TPB Ref.: A/YL-TYST/1334

**Temporary Open Storage of Construction Machinery and Construction Materials, Recycling Materials and Used Electrical Appliances with Ancillary Workshop for a Period of 3 Years at Lots 366 RP (Part), 371 S.B (Part), 372 S.A, 372 S.B, 373, 374, 375 RP (Part), 376 (Part), 377 (Part), 378 (Part), 379, 380, 381 RP (Part), 458 (Part), 459, 460, 461, 462, 463, 464, 471, 472, 1323 (Part), 1324, 1325 (Part), 1337 (Part), 1338 (Part), 1339, 1340 (Part), 1341, 1342, 1344 (Part), 1345 (Part), 1346 (Part), 1349 (Part), 1350 (Part), 1351 (Part), 1353 (Part), 1354, 1355 (Part), 1356 S.A (Part), 1356 S.B, 1357, 1358 RP, 1359, 1360, 1361, 1362, 1363 RP, 1365 (Part), 1366 RP (Part) in D.D.119 & Adjoining Government Land, Yuen Long, N.T.**

As discussed, please find the following comments from DSD on your submitted Drainage Impact Assessment for your reference:

## DRAINAGE IMPACT ASSESSMENT

Drawing No:  
D01

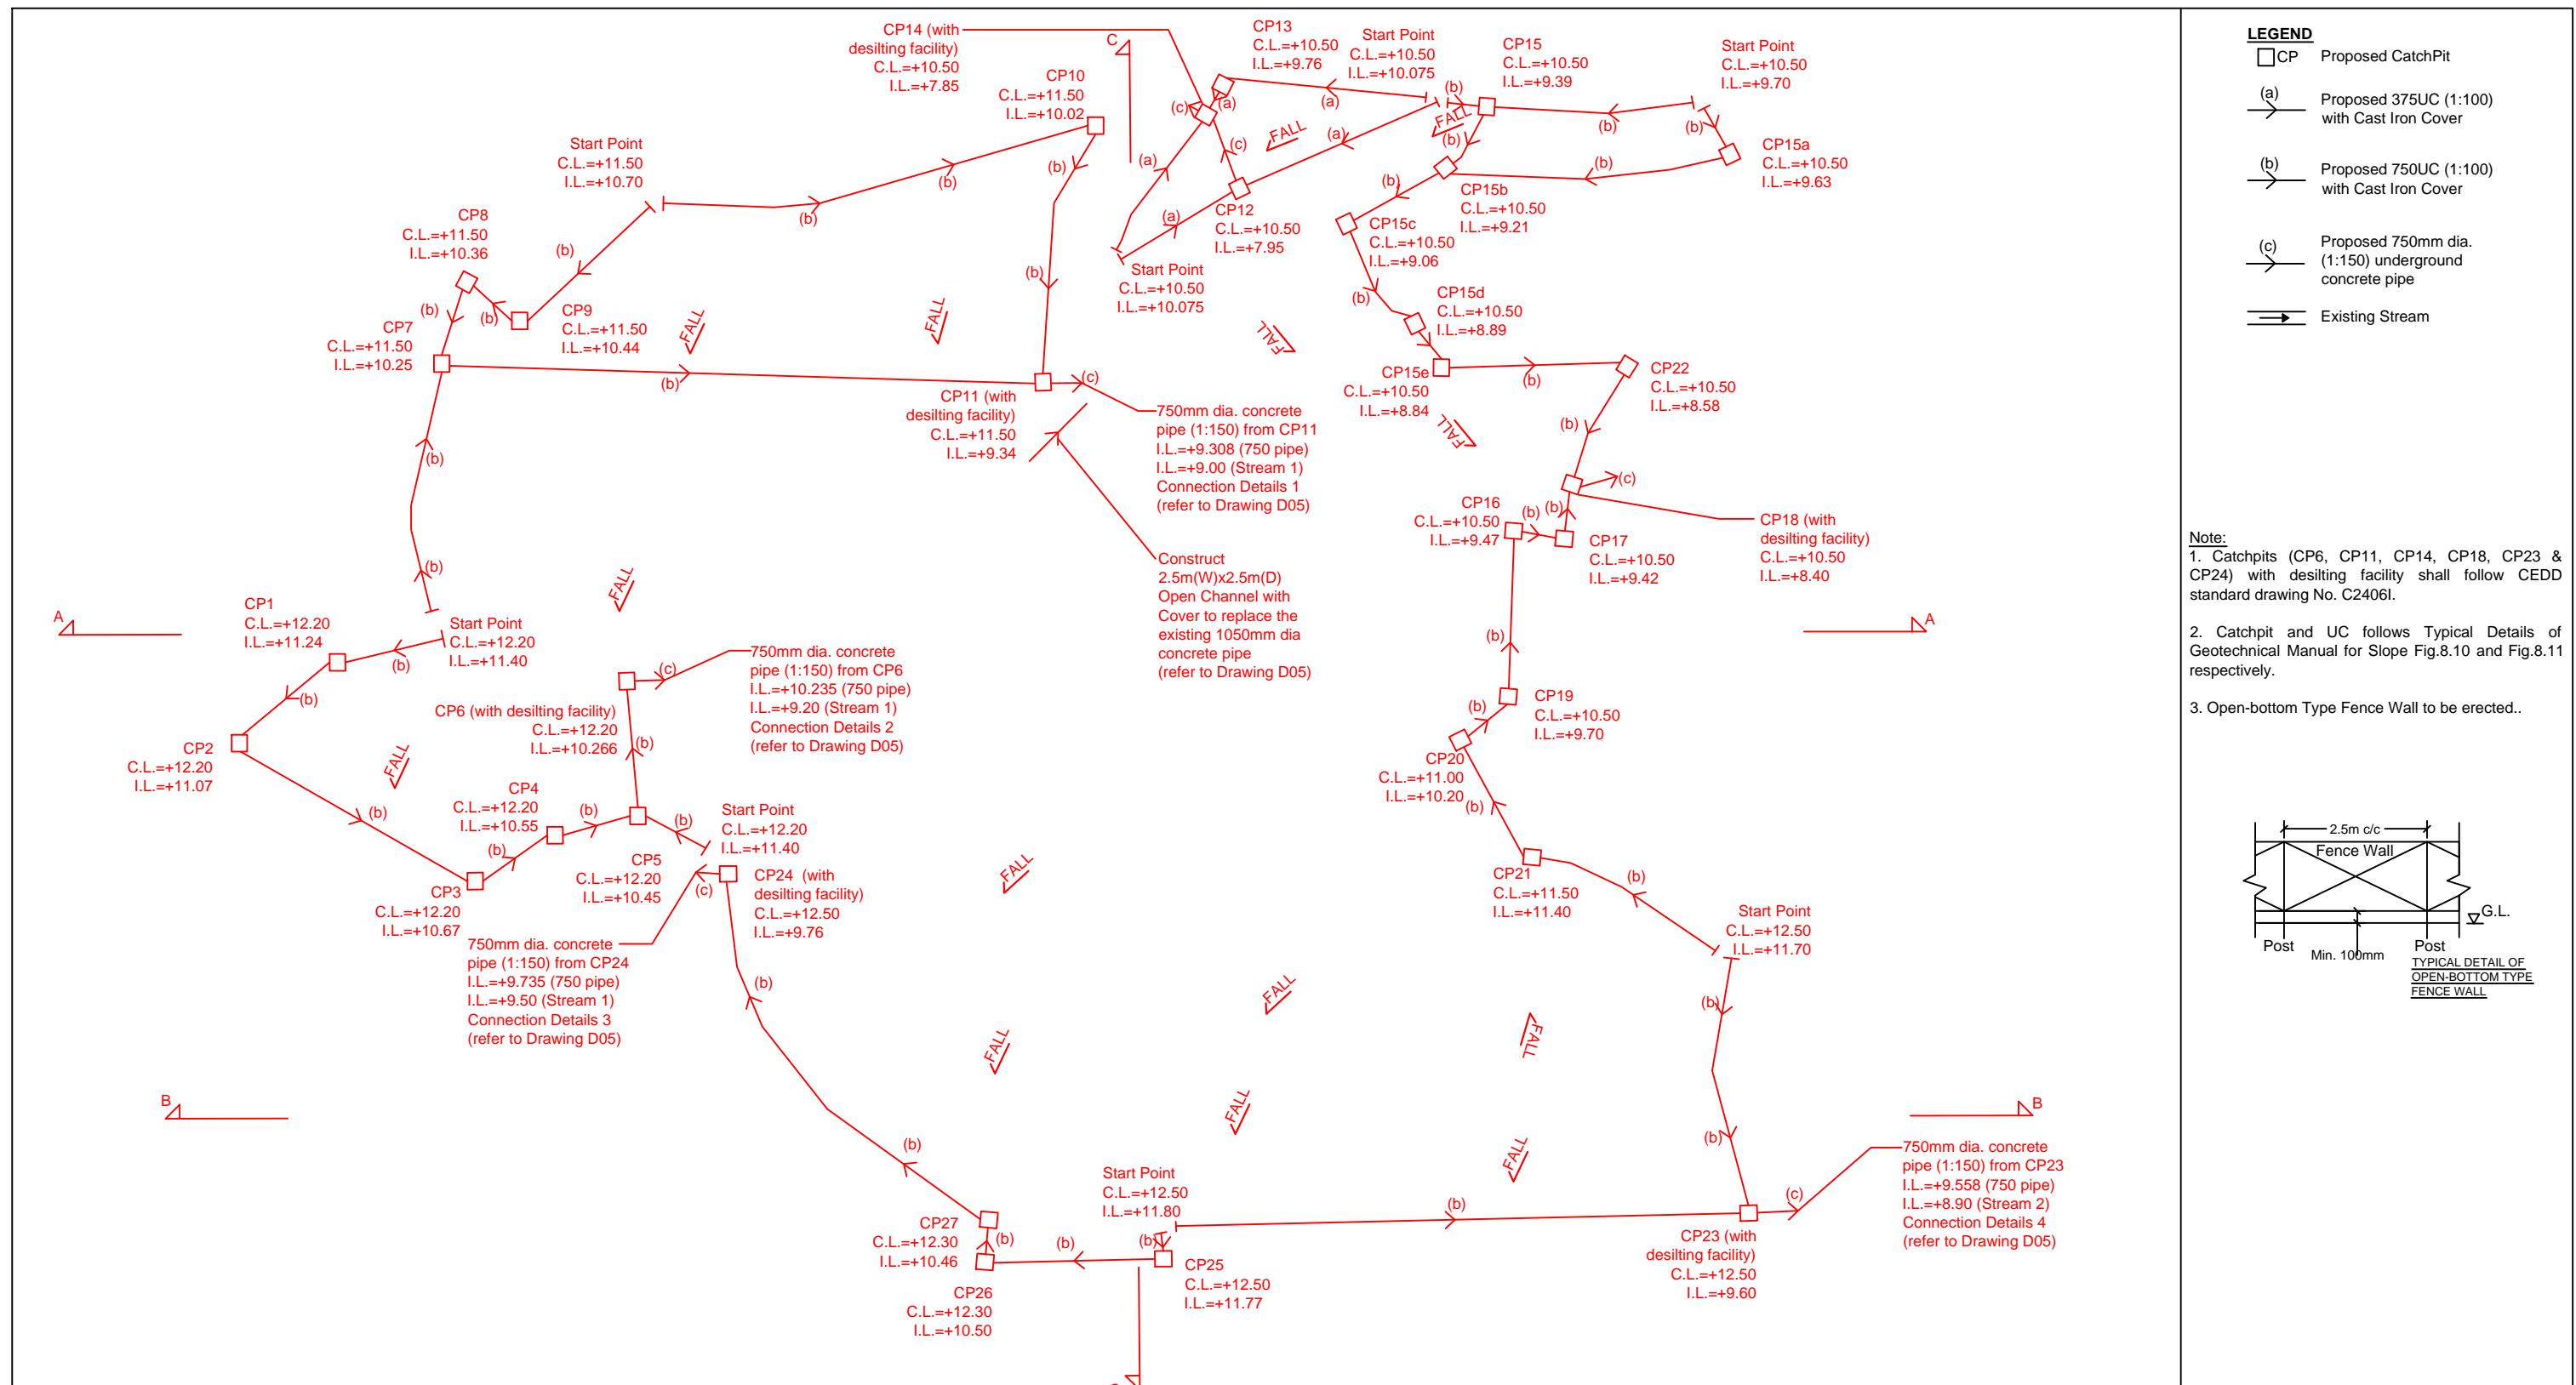
- Peripheral surface channels shall be provided along the site boundary of the lower sides to collect the surface runoff accrued on the application site and to intercept the overland flow from the adjacent lands (e.g. near Lot Nos. 1338, 1343, 1344, 1351, 1356 S.B, 1358 RP &1360). **Peripheral channels have been provided.**

- Please indicate the gradient and invert level of the outlet pipe at Stream 1 & 2. Please also indicate the invert level of the stream bed level at the discharge point and provide details/section of the discharge pipe to the stream. **It is indicated in Drawing D01 and D05**

- The invert level of CP6 (+10.53mPD) should not be higher than the invert level of upstream CP5 (+10.45mPD), please review. **It is revised accordingly.**

Drawing No:  
D03

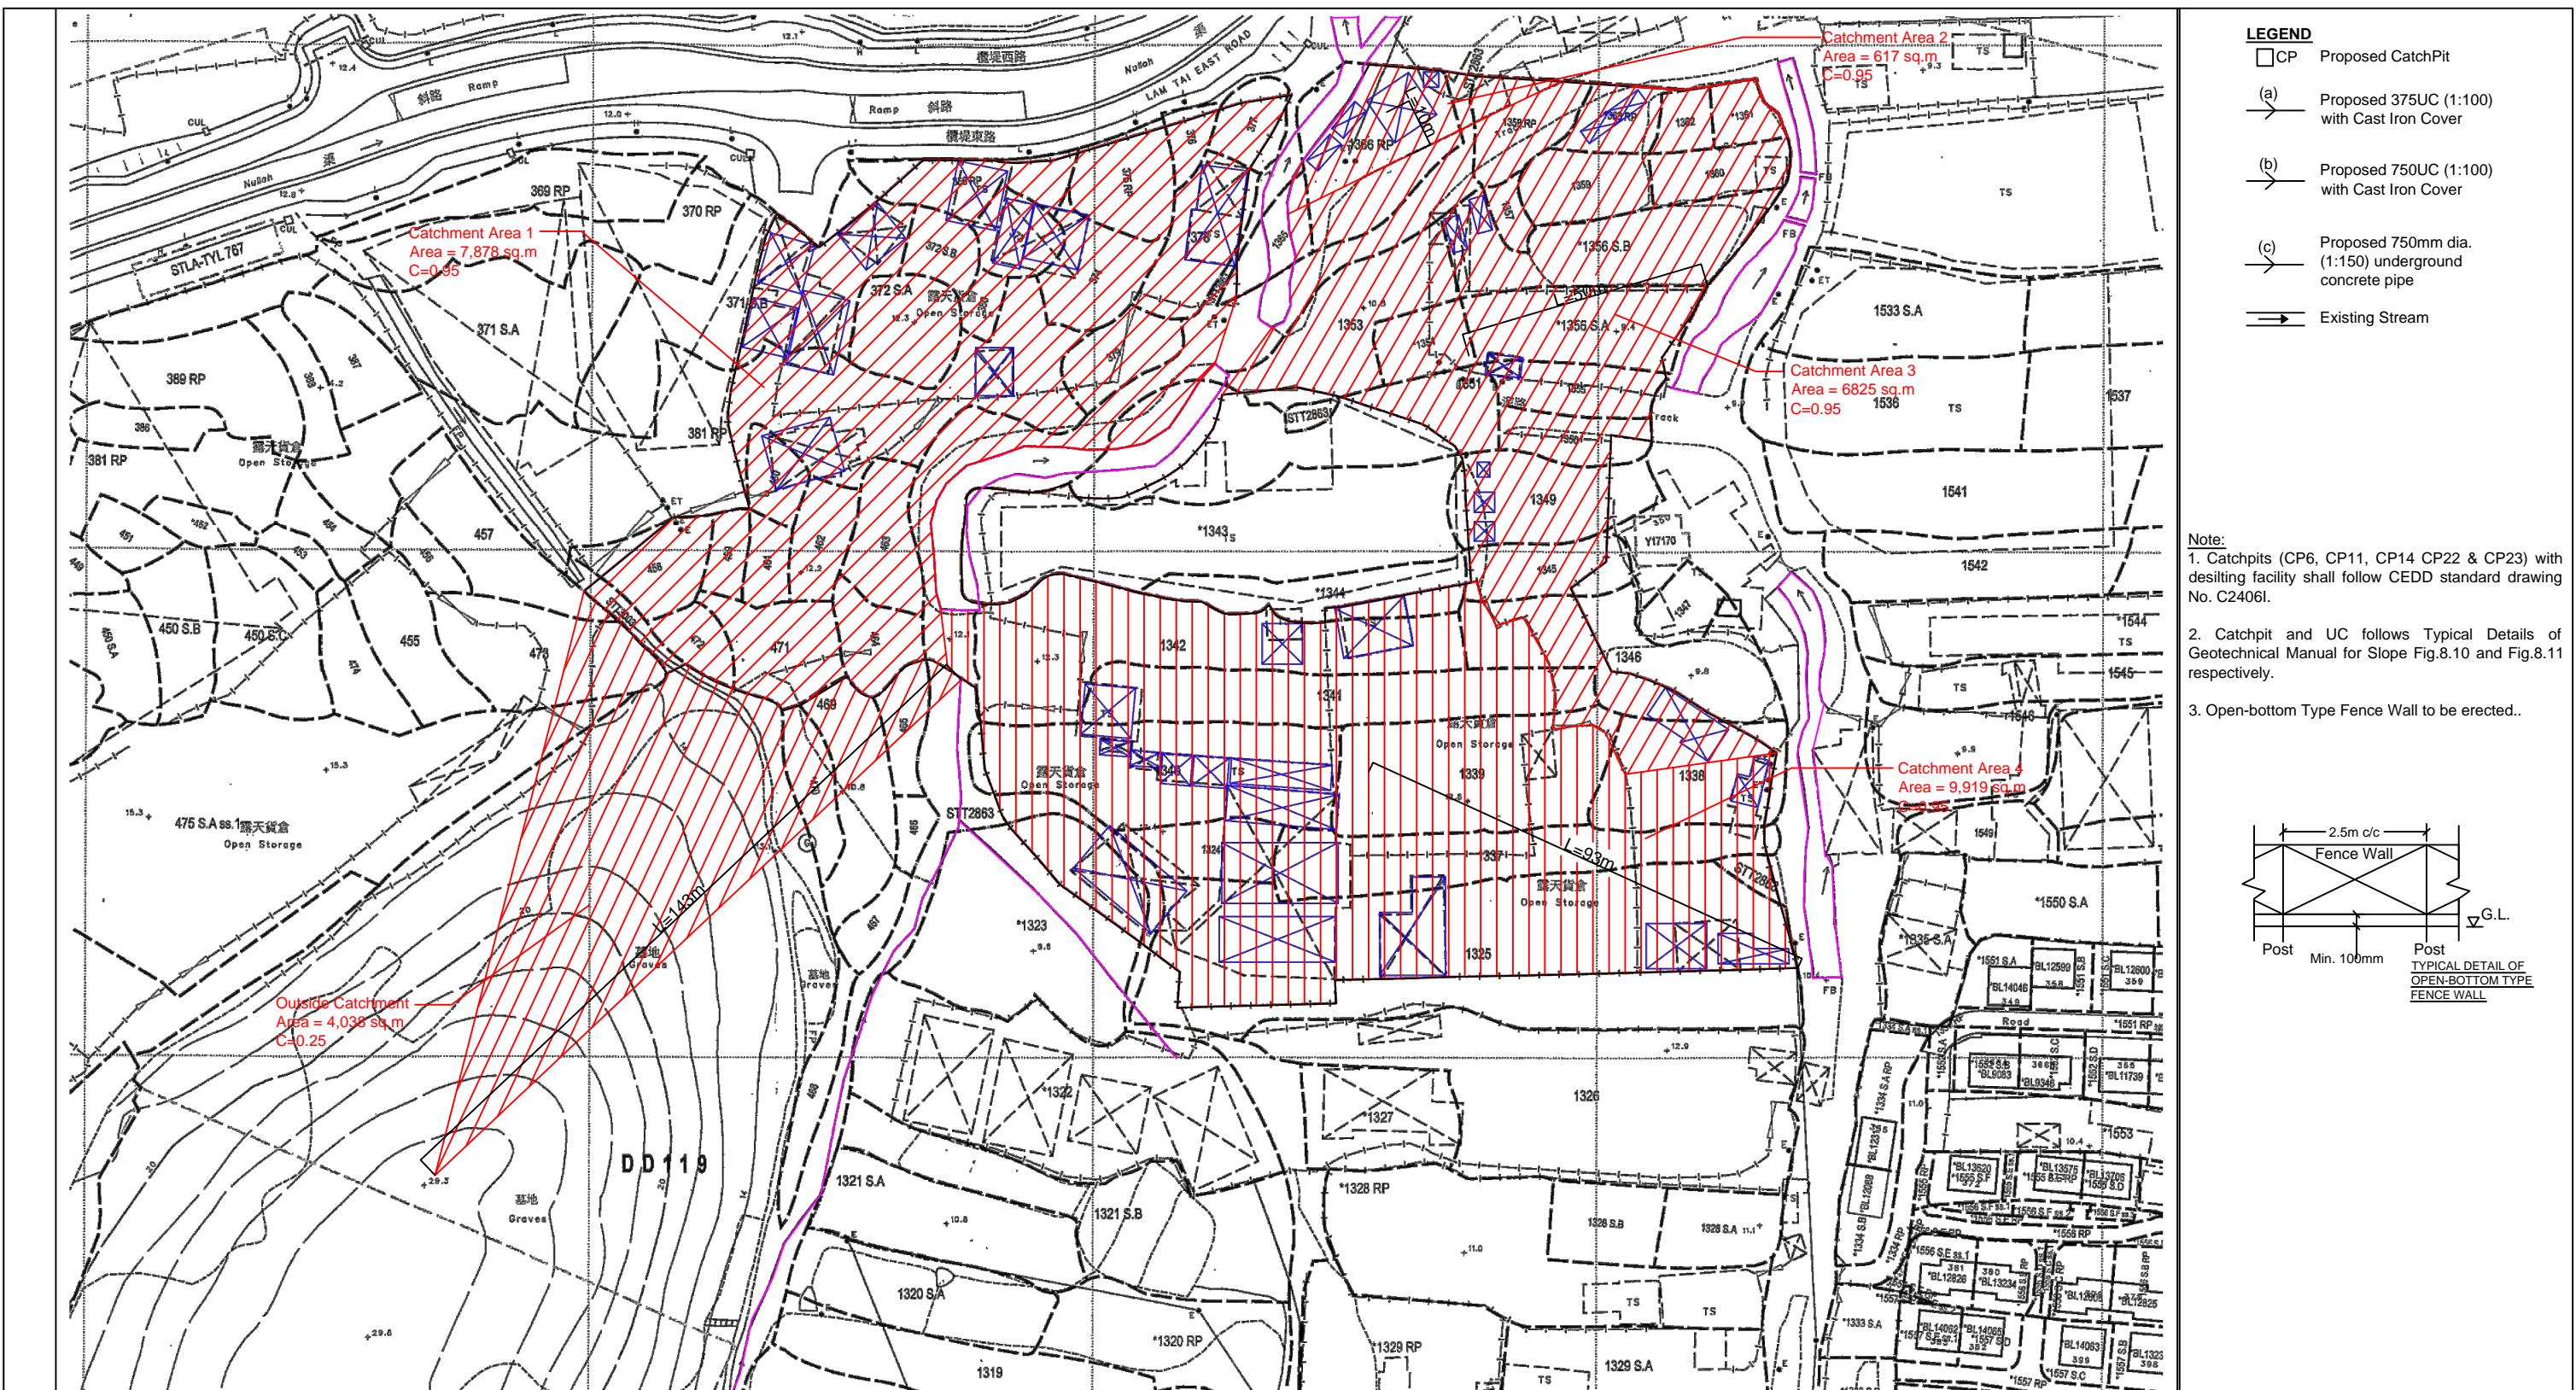
- Please clarify why Lot Nos. 1356 S.B, 1357, 1359 & 1360 which are within your application site as shown in Appendices A & B are excluded from the catchment area plan. **These catchment areas have been considered.**
